# Product Change Notice (PCN)

PCN Number: PCN-0451201R-02

Product(s) Affected: *PJ-056*

PREVIOUS CUI DEVICES DETAIL / IMAGE			NEW CUI DEVICES DETAIL / IMAGE		
	MATERIAL	PLATING			
center pin	brass	tin			
terminal 1	brass	tin			
terminal 2	copper alloy	tin			
terminal 3	copper alloy	tin			
plastic	PA66

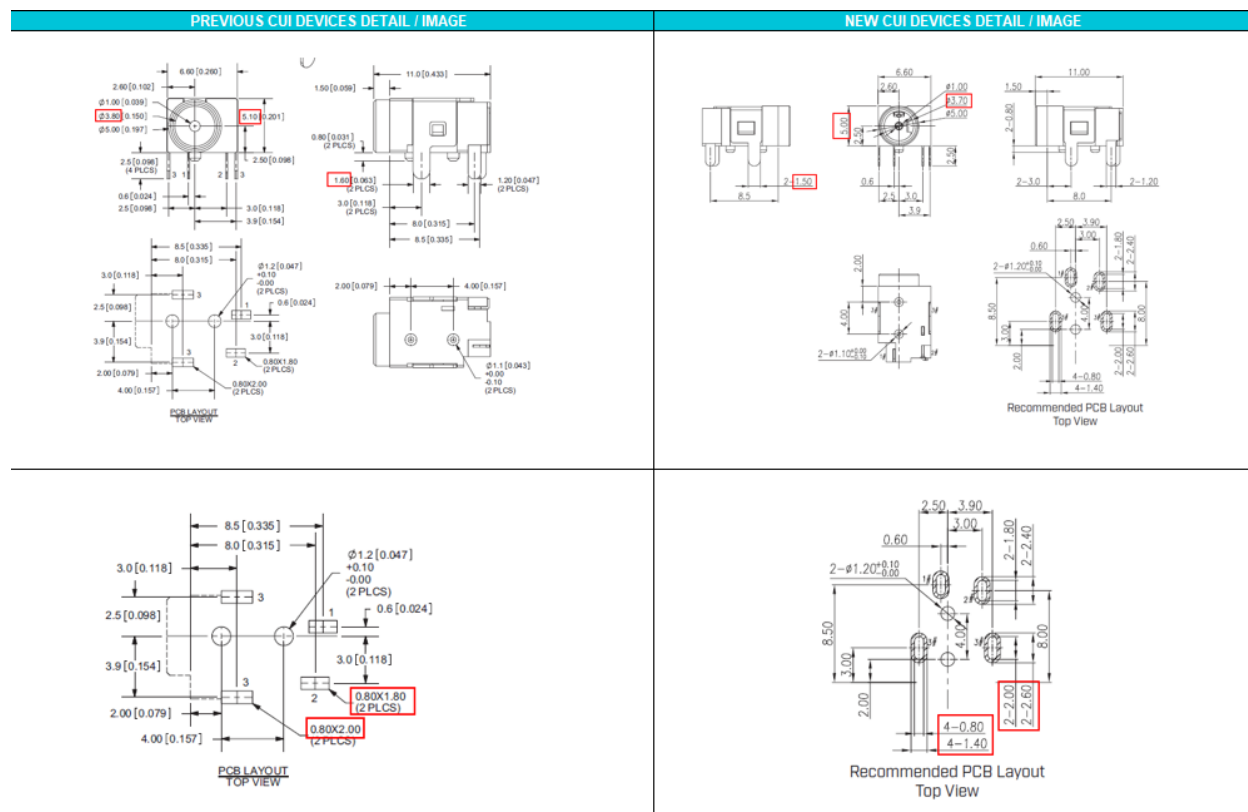
Description of Change: *Minor Housing and Material Difference. See image Below*

DESCRIPTION	MATERIAL	PLATING/COLOR
terminal 1	brass	tin
terminal 2	copper alloy	tin
terminal 3	copper alloy	tin
housing	PBT (UL94V-0)	black
